# STAFF REPORT

**TO:** Council **MEETING DATE:** January 23, 2024  
**FROM:** Planner II **FILE NO:** 3220-GibsonsWay-702  
**SUBJECT:** **OCP and Zoning Amendment for a 5-unit residential development at 702 Gibsons Way**

Figure 6: Comparison Site Plan and Elevation with 0.80 FSR above and 0.53 FSR below

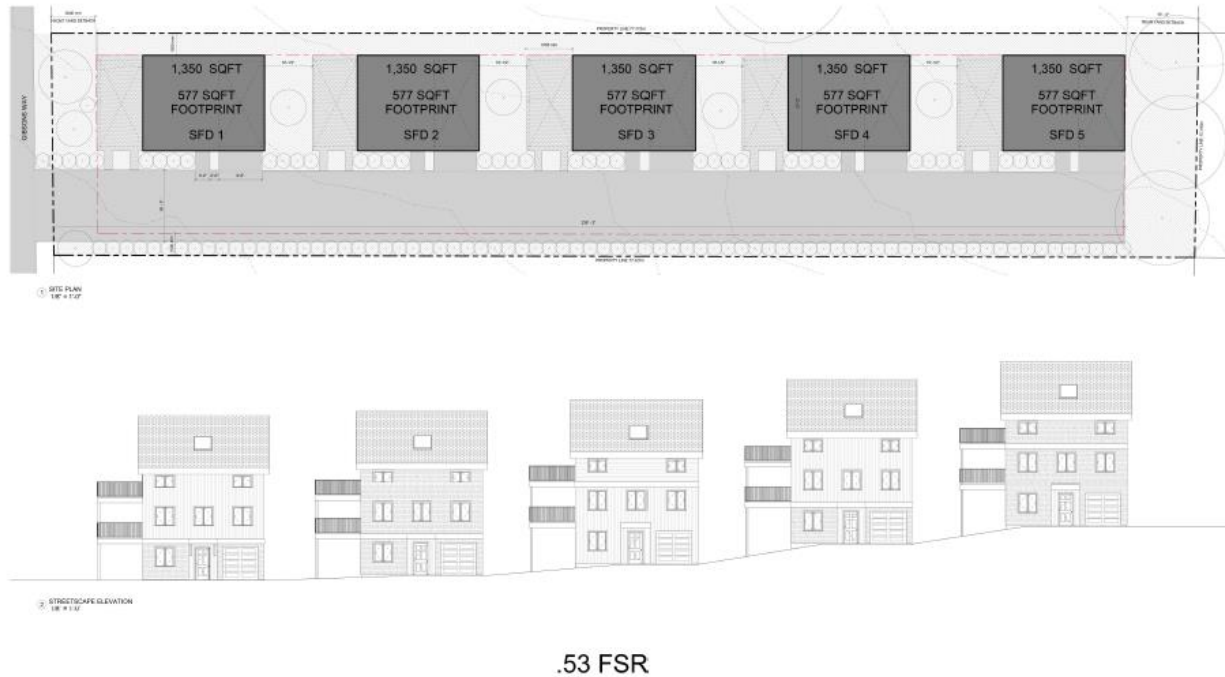
The Architect provided a comparison of what the development would look like with a 0.80 FSR. Figure 6 shows the 0.80 FSR renderings compared with the proposed 0.53 FSR. The main difference is the unit size and the greenspace reduction. The 3 m building separation is reduced to significantly. The Architect noted that the 0.80 FSR rendering was not checked for building or fire code compliance.
